Re: IFB FQ18102/KKB
Replacement of Chiller and Cooling Tower Accessories
At Eight (8) Metro-Rail Stations: DC, MD, and VA
Request for Clarification/Information Response

**Solicitation FQ18102/KKB; Replacement of Chiller and Cooling Accessories at Eight (8)
Metro-Rail Stations: DC, MD, and VA
RFI Log Responses
RFI Responses/Clarifications-RFI No. 22 thru 52**

1 ELECTRICAL PLAN - NEW WORK (COOLING TOWER)
CWP D2-E-103

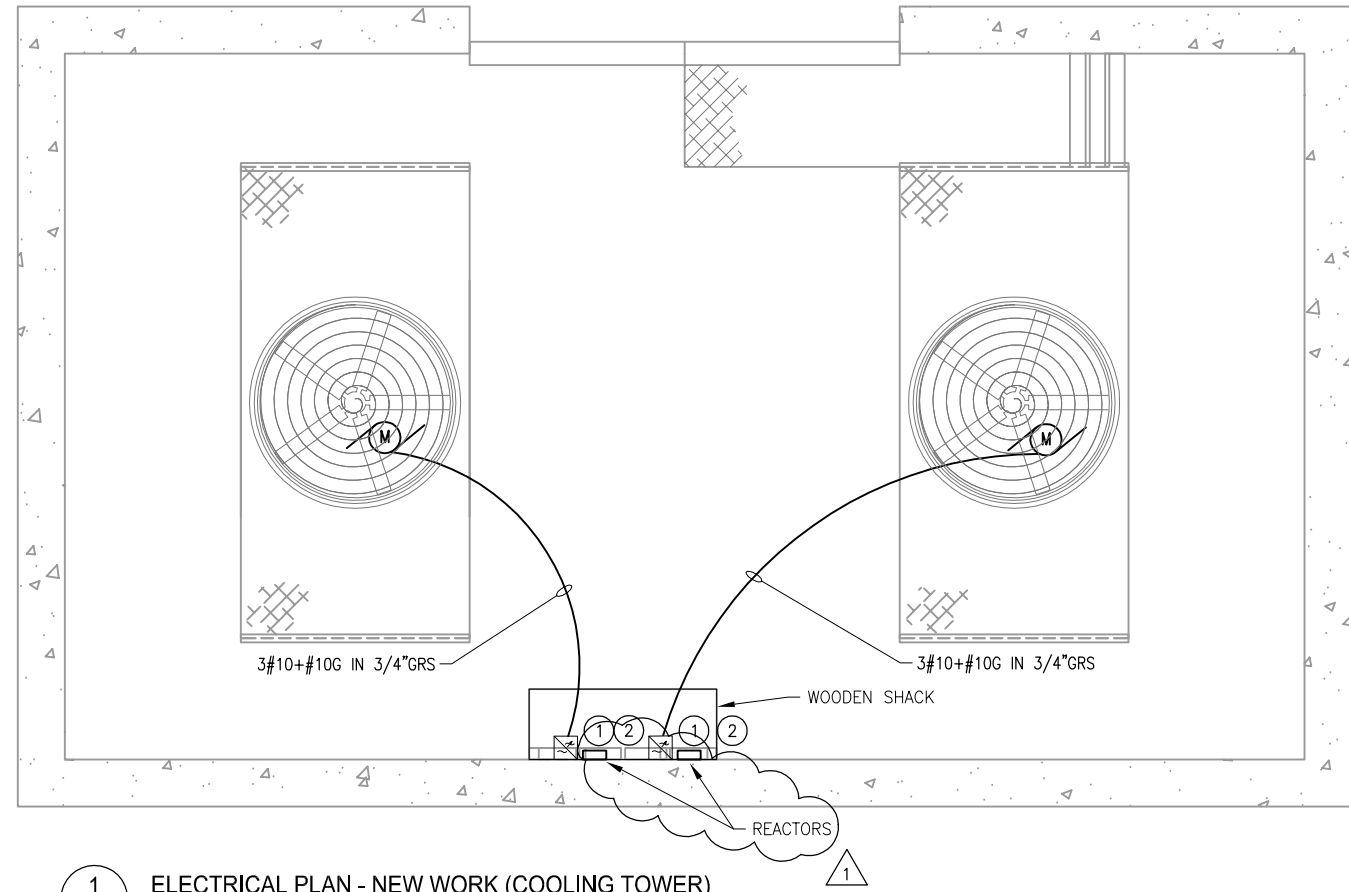
RFI No.	Amendment No.	RFI Description	RFI Response
22		There is a common note on the electrical drawings that states "provide filters for VFD's as required". Please confirm that the required filters are shown on the riser and no additional filters will be required. If additional filters are required, please indicate them on the risers, floor plans and equipment schedules.	Dwgs E-602 (Electrical One Line diagrams) show the line and load reactors (filters). NO additional filters are required.
23		D04 Federal Center: E-102 keynote 6 states we are to provide new wiring; however there is no information on the type, gauge or quantity of the wire. a. In addition, the note and floor plans don't indicate where this equipment is fed from. Please provide this information.	See revised dwg CWPD2-E-102.
24		D04 Federal Center: Drawing E-103 keynote 2 states we are to provide line and load reactors for the existing VFD's for the cooling tower fans; however, drawing E-602 does not show these reactors, nor does the equipment list on E-603. If these are required, please show them on the floor plan, riser and equipment list.	See revised dwg CWPD2-E-103.

1 ELECTRICAL PLAN - NEW WORK (CHILLER ROOM)
CWPE3-E-102

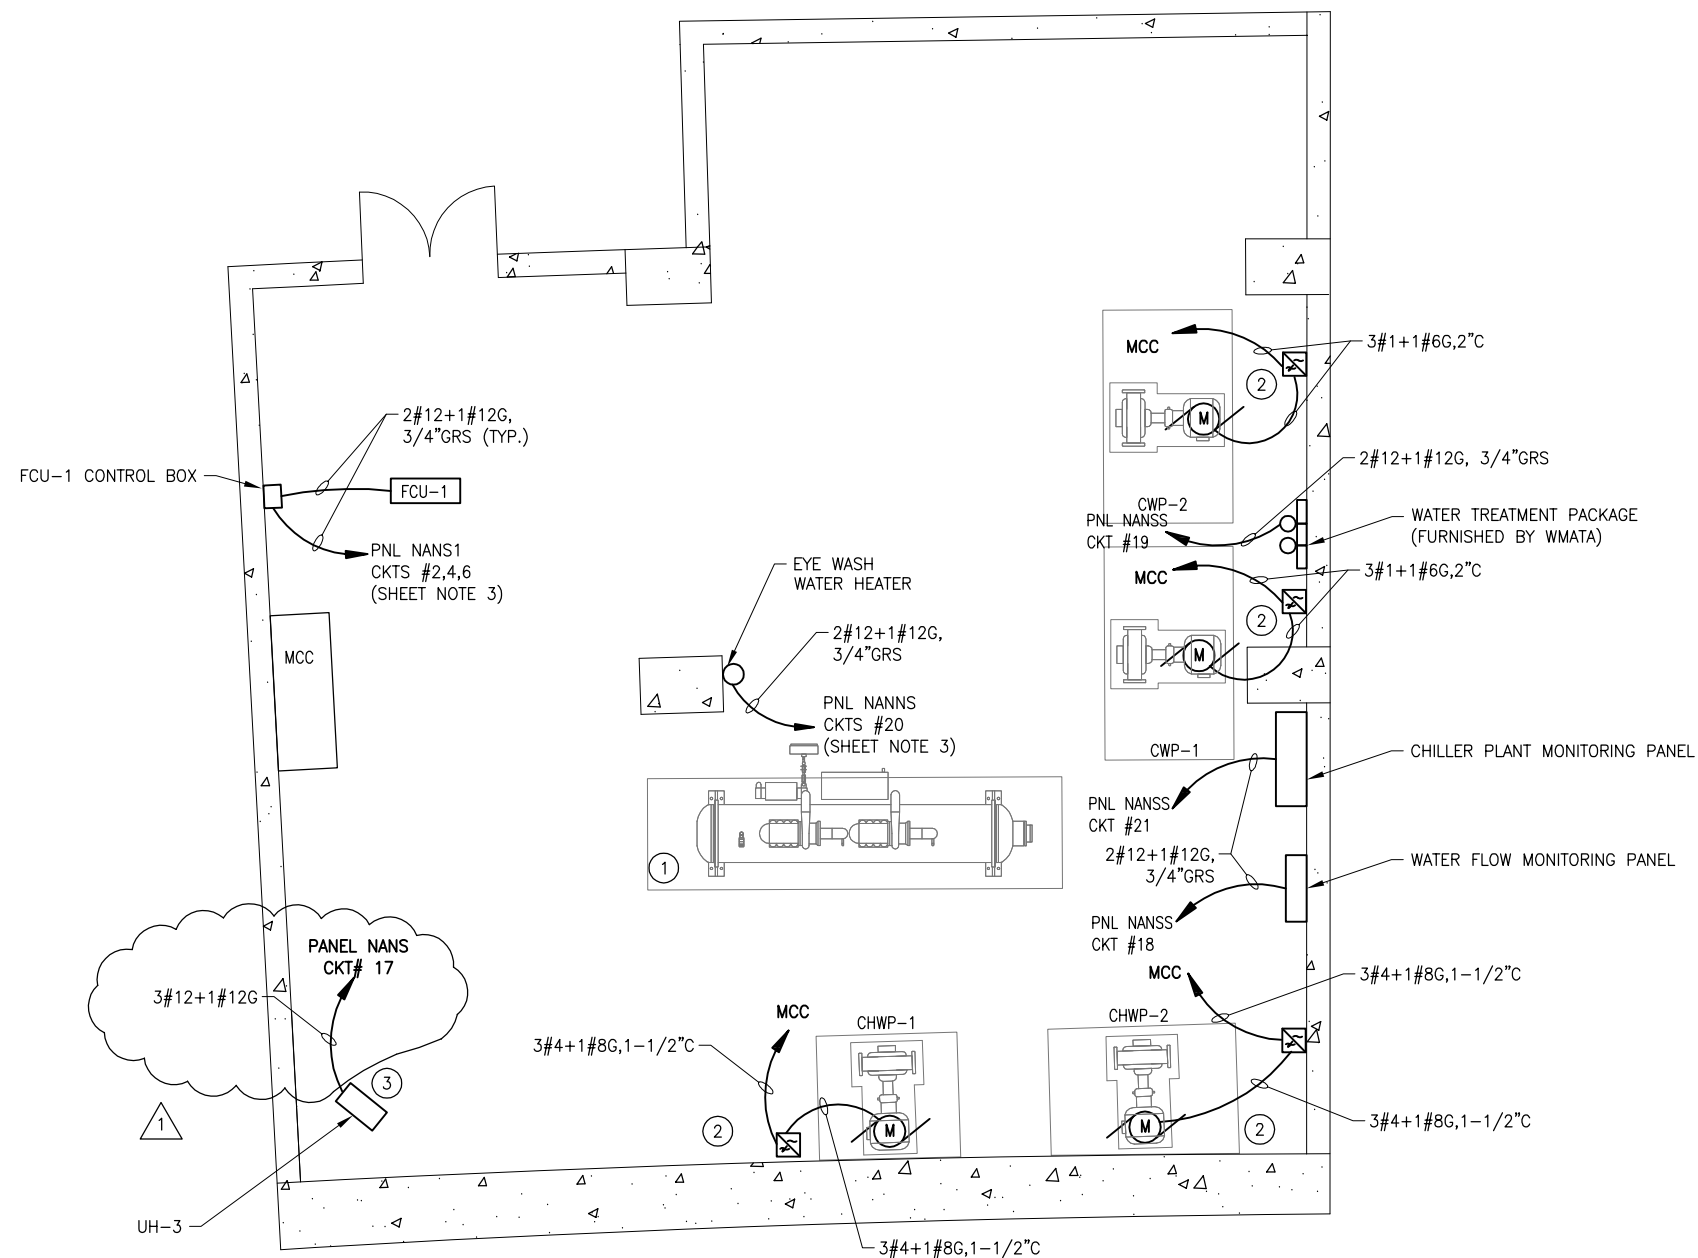
RFI No.	Amendment No.	RFI Description	RFI Response
		Please indicate the AIC rating for this switchboard/breaker.	
38		<p>E04 Columbia Heights:</p> <p>E-102 keynote 3 states we are to provide new wiring; however there is no information on the type, gauge or quantity of the wire.</p> <p>a. In addition, the note and floor plans don't indicate where this equipment is fed from. Please provide this information.</p>	See revised Dwg CWPE3-E-102.
39		<p>E04 Columbia Heights:</p> <p>Drawing E-103 appears to show new combo motor starters for CT-1 and CT-2; however plan note 2 on E-601 shows these as existing disconnects to remain, and E- 602 mirrors the condition shown on E-601. No new starters/disconnects are shown on the equipment list (E-603) for the CT's. Please indicate what the device is, and if it's existing or new.</p> <p>a. If it's new, please show it on the riser, floor plan and equipment list.</p>	There are no motor starters; these should have been shown as existing disconnects. See revised Dwg CWPE3-E-103 & CWPE3-E-602.

B ELECTRICAL SINGLE LINE DIAGRAM - NEW WORK
CWPE3-E-602

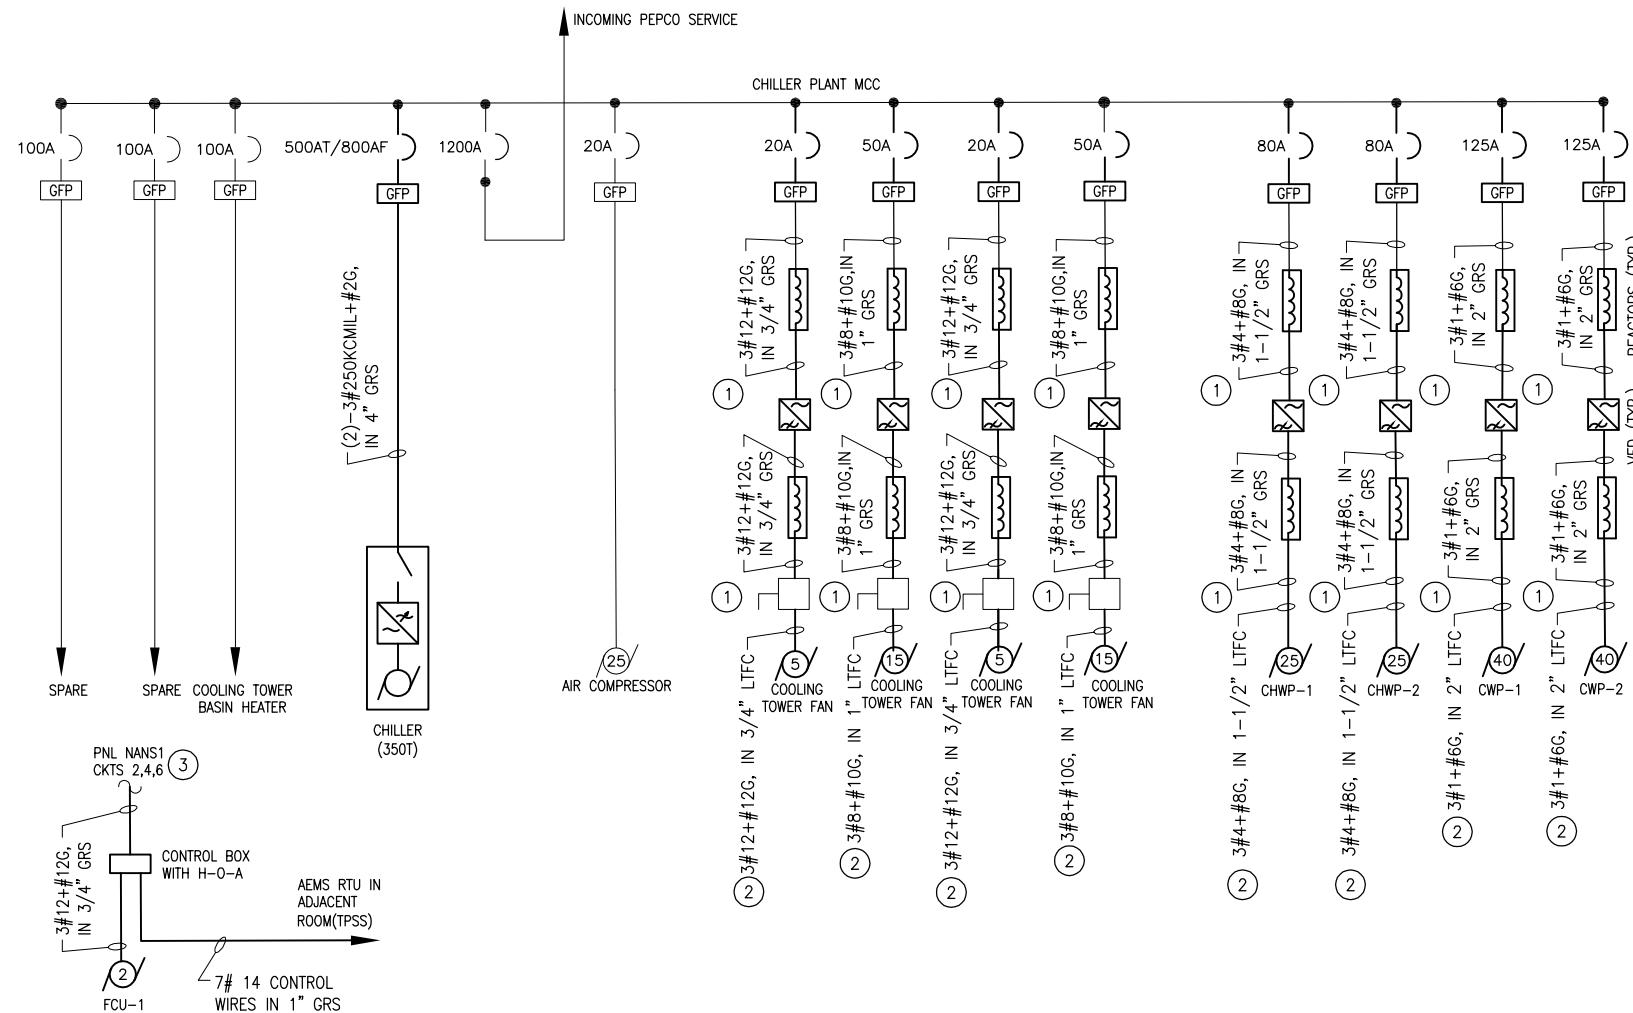
40		<p>E04 Columbia Heights:</p> <p>Plan note 3 on E-602 states we are to remove load wires from circuits 32, 34 and 36 in panel NANS;</p>	Panel NANS schedule is not shown on dwg CWPE3-E-603; the 24 ckt panel is NANSS. See Sheet Note 1 on dwg CWPE3-E-603, but
